Road Safety Audit Report

Pescadero Creek Road

Pescadero Creek Road Road Safety Audit Report

*Prepared by
Road Safety Audit Team
December 22, 2022*

CATEGORY LINK	OBSERVATION #2	
Intersections	Channelization, Intersection Site Distance, Placement of markings	
SITE SPECIFIC Location	Redwood Drive	
Horiz. Alignment	TANGENT ☐ CURVE ☒	
MAINTENANCE SECTION	SECTION La Honda	
	SEGMENT 11	
FREQUENCY	SEVERITY	RISK RATING
Low	Medium	C
BAND II

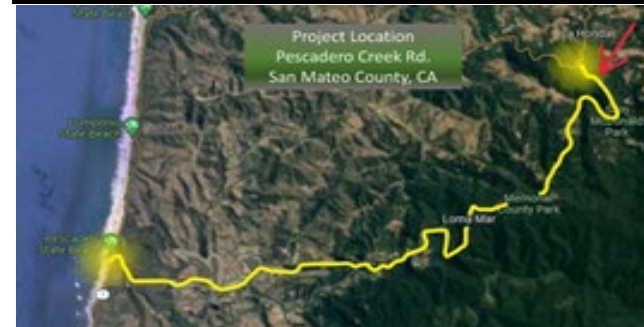
Observations: Redwood Drive T-intersection (1 motorcycle crash) - wide throat intersection, lack of channelization, shoulder encroachment, wide pavement, bikes likely use shoulder of 4-6 ft., stop line setback is 10-12 ft from projected edgeline, limiting sight distance looking west, and concern regarding gap acceptance and exposure time to turning traffic leading to intersection conflicts

Suggested Improvements: Relocate stop line 5 ft from projected 11 ft. Edgeline. Mark a shorter turn radius and eliminate long tapered edgeline. Double post R1-1 STOP. Consider use of concrete or painted splitter island. Use barrel wrap (black/yellow) around post of splitter island installed STOP. Accommodate transition if needed for shoulder (bike traffic) Effect: Reduce exposure time of turning vehicles, improve sight lines (See Appendix # 7.).

CATEGORY LINK	OBSERVATION # 4	
Lane Departures	Bridge End Exposure	
SITE SPECIFIC Location	Pescadero Crk Bridge	
Horiz. Alignment	TANGENT ☒ CURVE ☐	
MAINTENANCE SECTION	SECTION Loma Mar	
	SEGMENT 7	
FREQUENCY Medium	SEVERITY Medium	RISK RATING C
BAND II

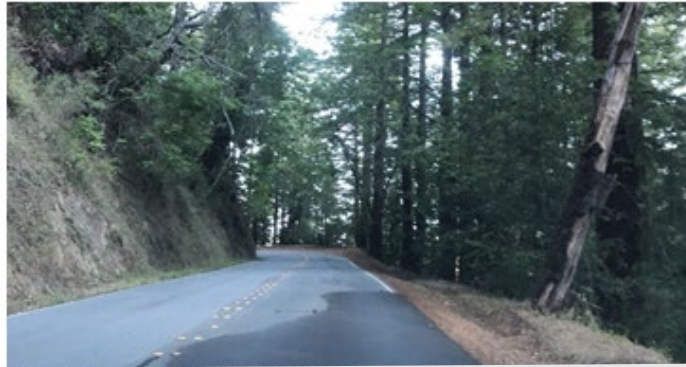
Observations: Neither end of the bridge has a crash attenuator to shield the curb or handrail. Delineation is missing or in poor condition. EB approach is in a curve and lacks delineation for curve.

Suggested Improvements: Use bridge post mounted delineators; upgrade hazard markers (placement should be edge of sign parallel with edge of hazard); use fluorescent yellow sheeting; review site for crash attenuators; review need for narrow bridge warning signs and centerline and edgeline supplemental retroreflective, raised pavement markers.

Photo A3 (SMC video; inset FHWA) Above Looking eastbound on PCR just east of Butano Cut-off Rd.; inset @ Butano Cut-off Rd.; Photo A4 (SMC video) Below Looking westbound on PCR approach Alpine Road.

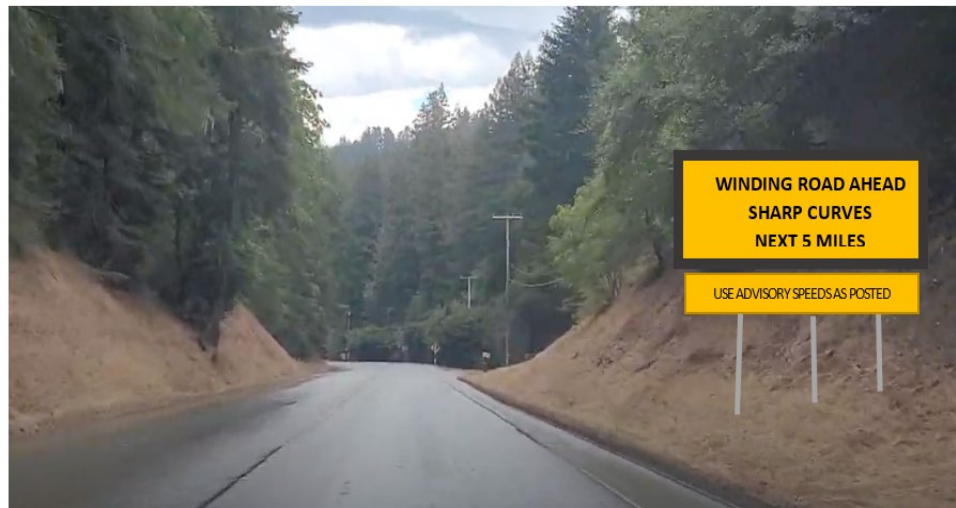
Need for supplemental advance warning signs for downgrade long tangent section approaches to sharp curves. In a few locations the change is evident in ROW, shoulder presence/absent, pavement width, curvature, degree of curvature, driveway frequency, intersection sight distance, etc. Drivers are experiencing a few long stretches of tangent sections between sharp curves, where speeds typically increase. A need exists to warn users. Switchback curve warning sign is seen in distant background (photo A4). This is where a warning sign is needed for change in alignment with reminder after switch back in next tangent section. Sign Design,

At least two long tangent sections (Lat-Long Coordinates provided below) downgrade can increase the possibility of a lane departure in a curve. Motorists sometimes increase their speed in longer tangent sections between curves on winding roads of considerable length. Provide upstream advance notice. Suggestion SHARP CURVE AHEAD/REDUCE SPEED TO XX MPH. Follow with standard horizontal warning sign at advance preview distance Table 2C-4, MUTCD Fed.

Note: These proposed signs as depicted in Photos A5-A6 would supplement, not replace, the necessary warning signs to be installed according to the curve analysis study recently performed by a contractor. Photos below show suggested type of warning sign superimposed onto photos

Image A8 - Loma Mar Section , Segment 5,

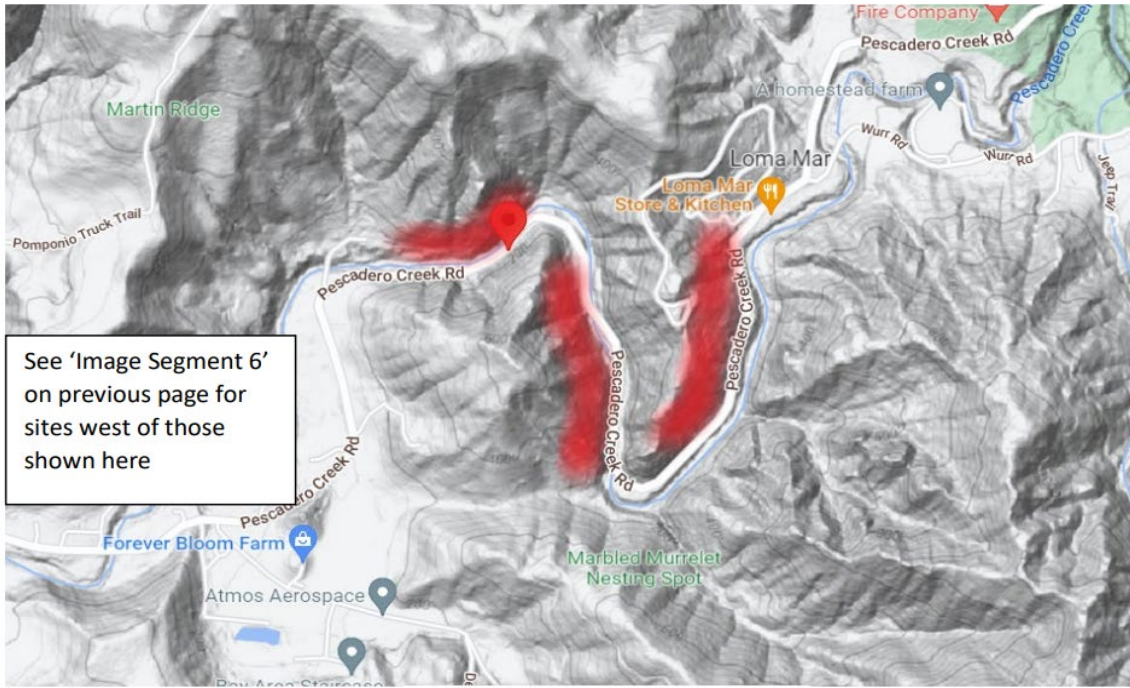
Numerous locations were noted during the ride-through portion of the field review. A guardrail/barrier analysis should be conducted to determine how many additional sites may be candidates for redirected barrier. Red areas marked on map indicates sites for barrier or other roadway departure countermeasure consideration. Sections are Loma Mar and LaHonda.
